Access Compliance Report

Public Rights-of-Way

(Curb Ramps)

Intersection ID: 3163	Main Street: BASKERVILLE_AV	Cross Street: PROSPERITY_CHURCH_RD	Location: NE
ADA ID: 17FC2D66CDC8	Ramp Type: Perp	Initial Pass/Fail: Fail	Overall Compliance: No
Severity Score: 33.75			
Codes/Mitigation Info/Possible Solution		Field Measurements/Component Compliance

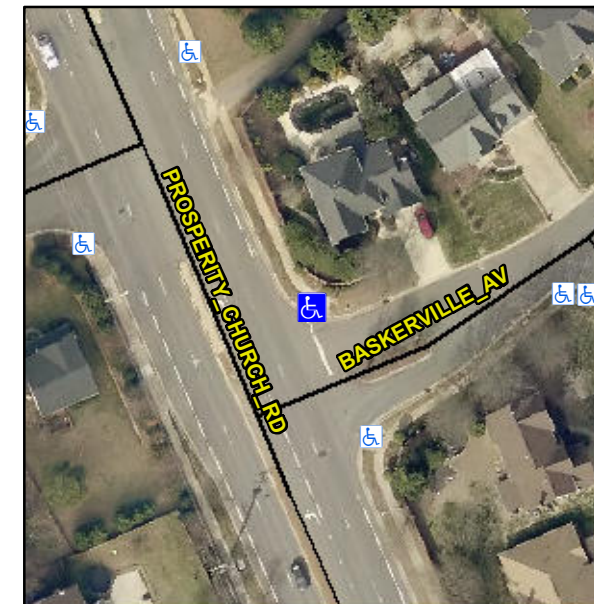
R304.5.1, R304.2.2

Compliance	Description	Data	Compliance	Description	Data
N/A	Ramp Length (in)	73.0	No	Ramp Slope (%)	20.0
No	Ramp Width (in)	40.0	Yes	Ramp XSlope (%)	1.5
N/A	Flare Type LT	N/A	N/A	Flare Type RT	N/A
N/A	Flare Slope LT (%)	N/A	N/A	Flare Slope RT (%)	N/A
N/A	Flare Traversable LT?	N/A	N/A	Flare Traversable RT?	N/A
N/A	Landing Length (in)	N/A	N/A	DWS Provided?	N/A
N/A	Landing Width (in)	N/A	N/A	DWS Contrast?	N/A
N/A	Landing Slope (%)	N/A	N/A	DWS Length (in)	N/A
N/A	Landing X Slope (%)	N/A	N/A	DWS Full Width?	N/A
N/A	Landing Curb? (Y/N)	N/A	N/A	DWS Offset (in)	N/A
N/A	Shared Landing?	N/A			
N/A	Gutter Ponding?	N/A	N/A	Gutter Slope (%)	N/A
N/A	Gutter Lip Ht (in)	N/A	N/A	Gutter X Slope (%)	N/A
N/A	Painted X Walk1?	No	N/A	Painted X Walk2?	N/A
	X Walk 1 Direction	To S		X Walk 2 Direction	N/A
N/A	X Walk 1 Width (in)	N/A	N/A	X Walk 2 Width (in)	N/A
	X Walk 1 Slope (%)	3.1		X Walk 2 Slope (%)	N/A
	X Walk 1 X Slope (%)	1.7		X Walk 2 X Slope (%)	N/A

Remove & Replace Entire Ramp.
